JAMES TUCKER
Lead Counsel
jtucker@idahopower.com

July 29, 2016

Re: Idaho Power Company, Hells Canyon Complex (HCC)
FERC Project No 1971
Application for Certification – Clean Water Act § 401

Figure 1. Daily mean HCC outflow DO from 2004 through 2014

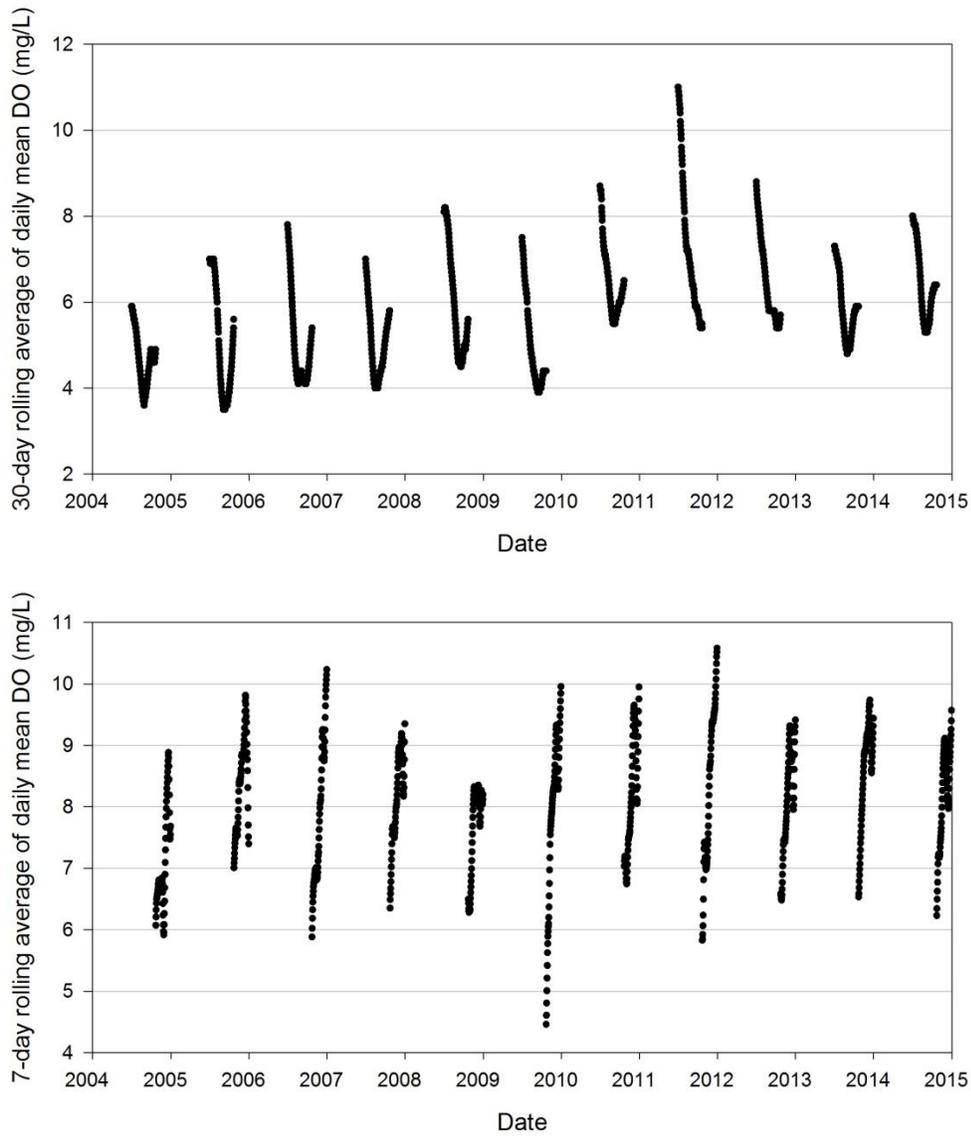
The period of record for all analysis of measured data is from 2004 through 2014. Starting the period in 2004 was selected because the SR-HC TMDL was approved in 2004. Because DO conditions could be expected to improve with SR-HC TMDL implementation, post-TMDL data are expected to be more reflective of current and future conditions than pre-TMDL data. Since an average over various periods is being calculated, any gaps in the 10 minute data were filled using linear interpolation. The resulting daily mean dataset (Figure 1) was then used for the remainder of the calculations. Corrections to the daily average values to account for DO saturation (as stated in the standards) were not required because the temperature conditions below Hells Canyon Dam result in 100% DO saturation values ranging from approximately 8 to 12 mg/L and all data considered in the summary of deficits is less than 6.5 mg/L.

During the low DO period of the cool water life and salmonid spawning periods there are statistically significant increasing trends in the 30-day (cool water life) and 7-day (salmonid spawning) HCC outflow DO conditions (Figure 2, Table 1).

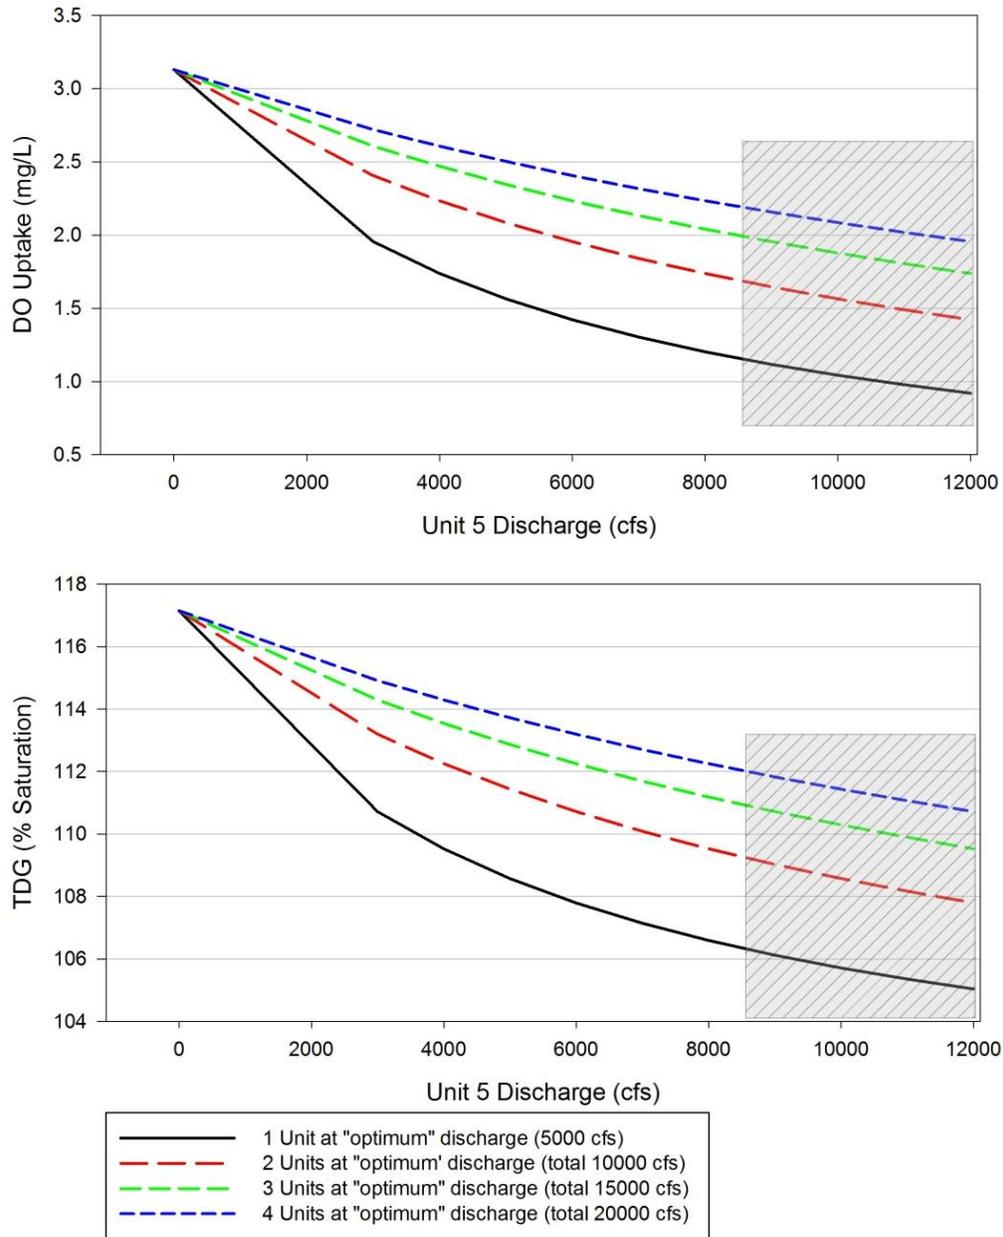
In the 401 application, IPC expressed confidence that the proposed operation could add 0.4 mg/L, at a minimum, to offset the calculated responsibility in the 401 application after full SR-HC implementation. In addition, based on Voith modeling information also presented in the 401 application, that the aeration systems have the potential to add 1.0 to 1.5 mg/L and remain below the 110% TDG criterion as represented in a well mixed downstream location (Figure 4). It is IPC's intention to operate the runners to add as much additional oxygen as possible within the current TDG limitations. Therefore IPC's proposal should result in the addition of enough oxygen to offset the 1.0 mg/L average annual average deficit as measured as an annual average net deficit from criteria at the HCC outflow over the July 1 through December 30 time period.

Figure 1. A comparison between daily maximum temperatures at RM 202 and RM 247 during the period of comparison of various Snake River tributaries to the Snake River relative to cold water refugia.

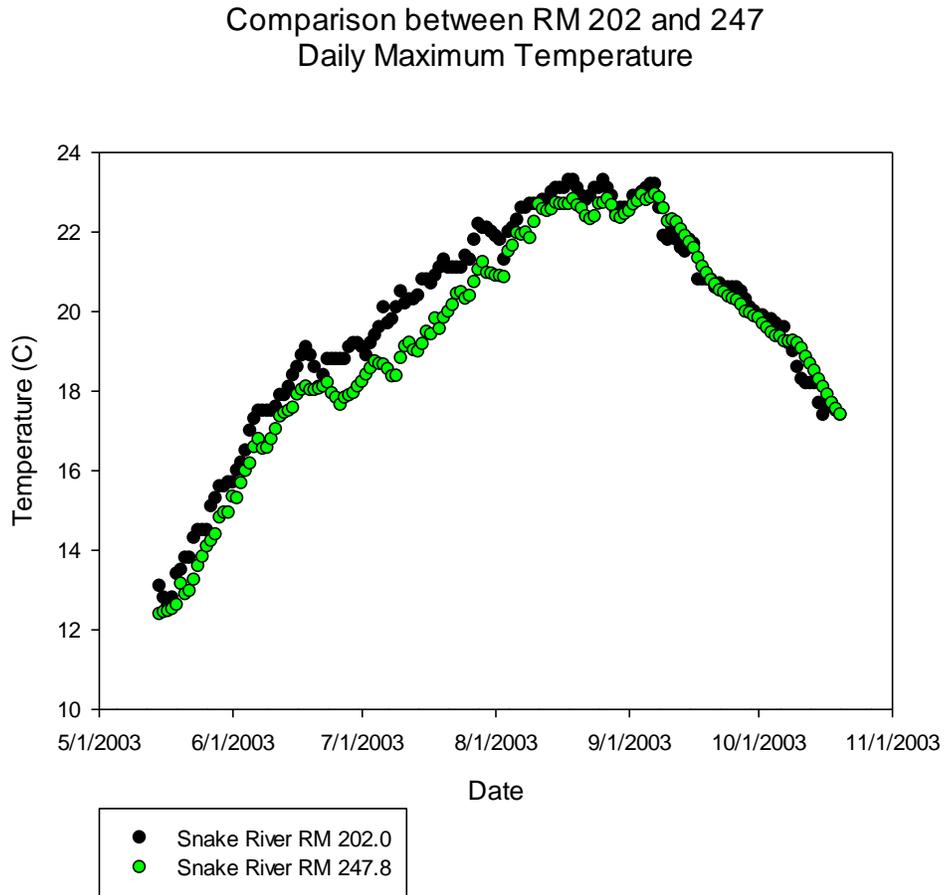
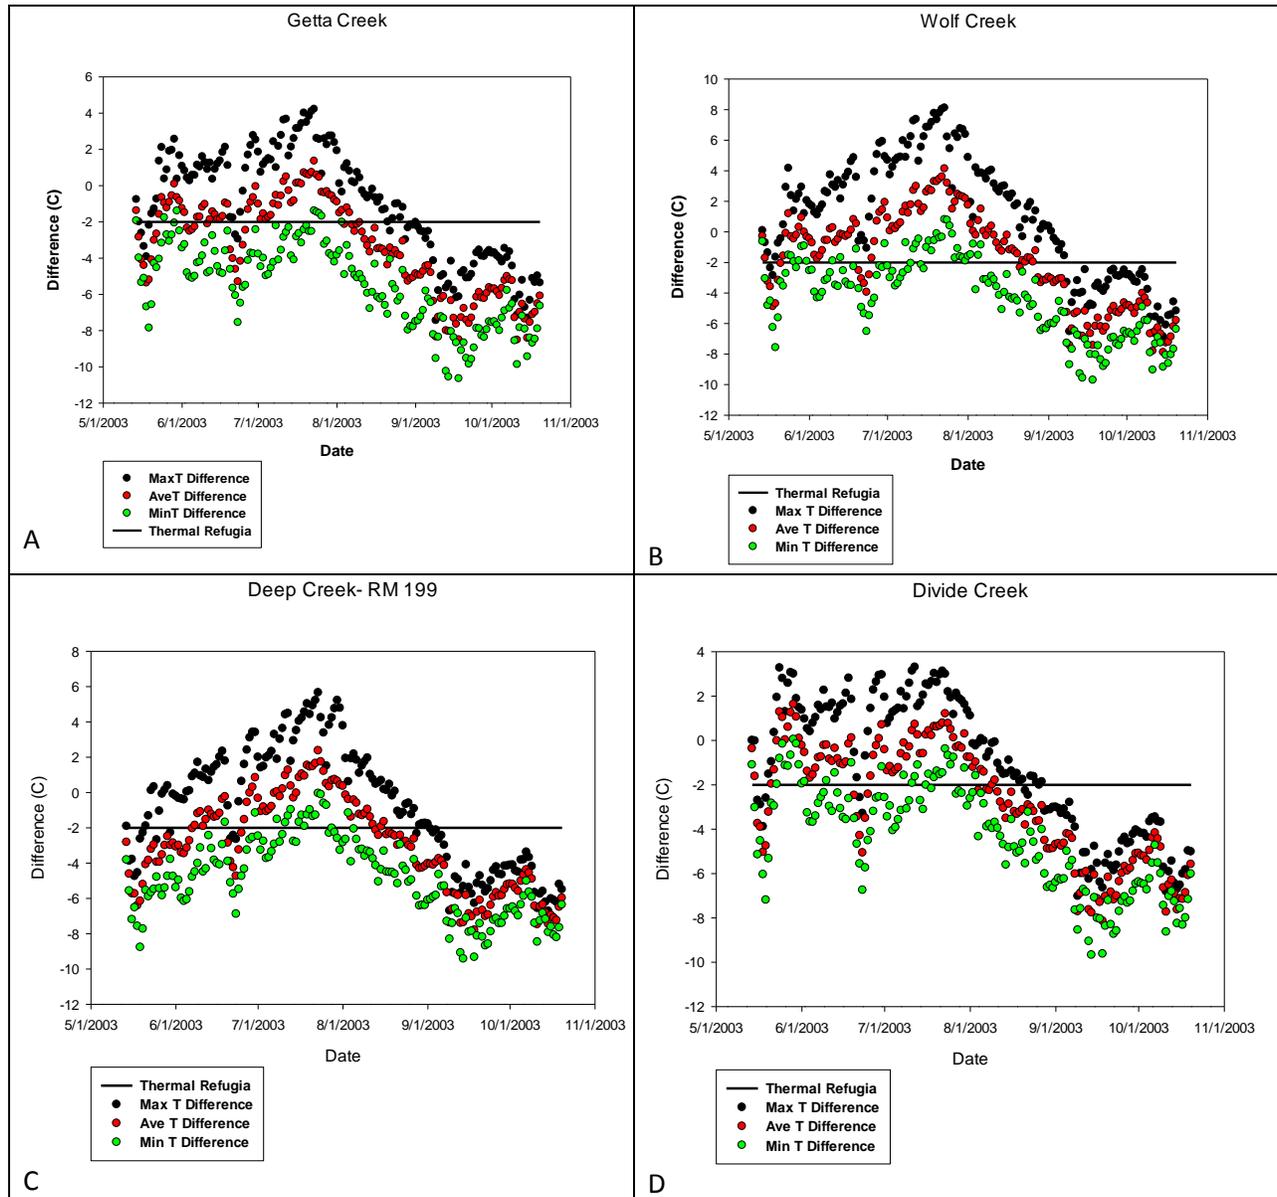
The following set of graphs compares daily temperature metrics at several tributaries in Hells Canyon to the daily maximum temperature in the Snake River. The two locations used for comparison to the Snake River are at River Miles (RM) 202 and RM 247. These two locations on the Snake River had the most complete data set relative to the information available for comparison to the tributaries. Figure 1 demonstrates that generally there is little difference in the daily maximum temperature between these two Snake River locations. There is some downstream warming as would be expected during the time period compared. The RM 202 (Figure 2) location is used as a comparison to tributaries that enter the Snake River between RM 206 and RM 190. The tributaries included in the comparison are Getta Creek (RM 205), Wolf Creek (RM 202), Deep Creek (RM 199), Divide Creek (RM 193) and the Imnaha River (RM 191). The RM 247 location (Figure 3) is used as a comparison to tributaries between RM 247 and RM 220. The tributaries used in this comparison are Deep Creek (RM 247), Granite Creek (RM 239), Sheep Creek (RM 229), Bernard Creek (RM 235), Three Creeks (RM 238), Kirkwood Creek (RM 220) and Temperance Creek (RM 223).

The temperature metrics from the tributaries used for comparison to the Snake River at these locations include daily minimum temperature, daily average temperature and daily maximum temperature. Because the CWR metric references the diel temperature cycle, these metrics offer an indication as to the extent during a diel cycle the tributaries meet the CWR definition. As indicated by the tributaries compared to RM 202 (Figure 2), all of the tributaries provide CWR during at least some portion of the day, with the exception of a few days in the middle of July, where all metrics exceed the -2 °C CWR definition. Generally, by mid August, the daily average temperatures start to drop below the -2 °C CWR definition which suggests that the majority of the diel cycle is providing thermal refugia. Finally, by around the first of September, all of the tributaries are providing CWR during the entire diel cycle.

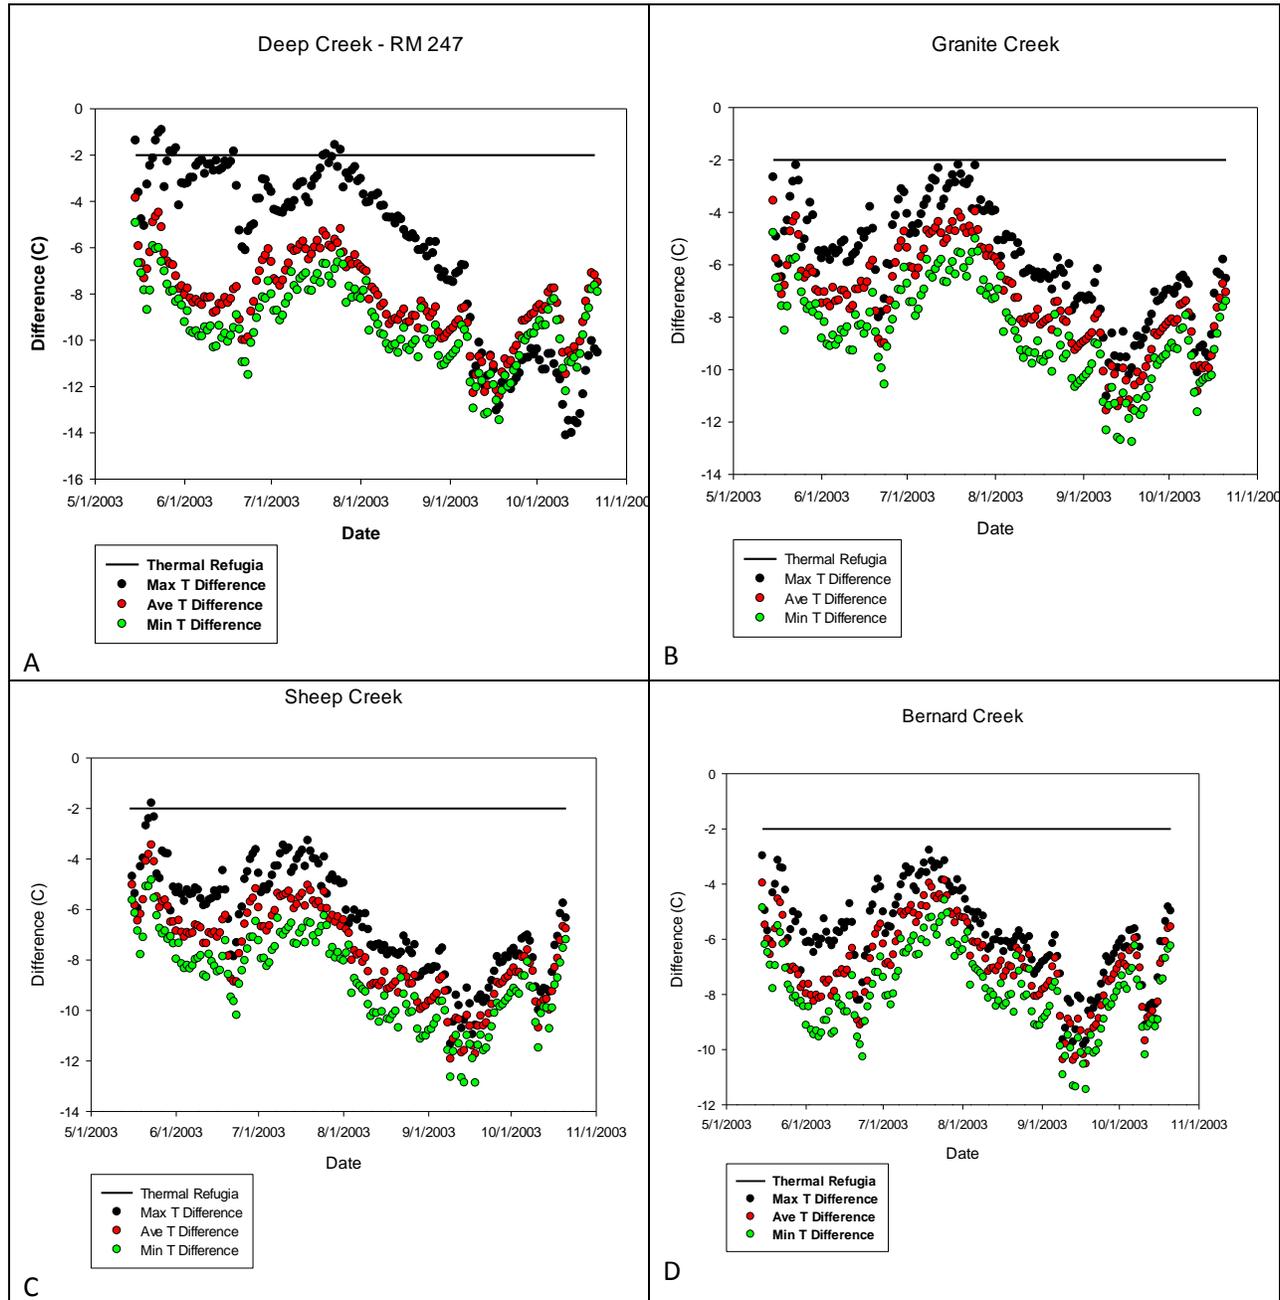
The tributaries in Figure 3 demonstrate a much colder pattern relative to the Snake River. All of the tributaries with the exception of Temperance Creek and Kirkwood Creek provide significant CWR during all portions of the diel cycle. Temperance Creek and to a lesser extent Kirkwood Creek show patterns similar to those in the proximity of RM 202. The primary difference for the tributaries that meet the
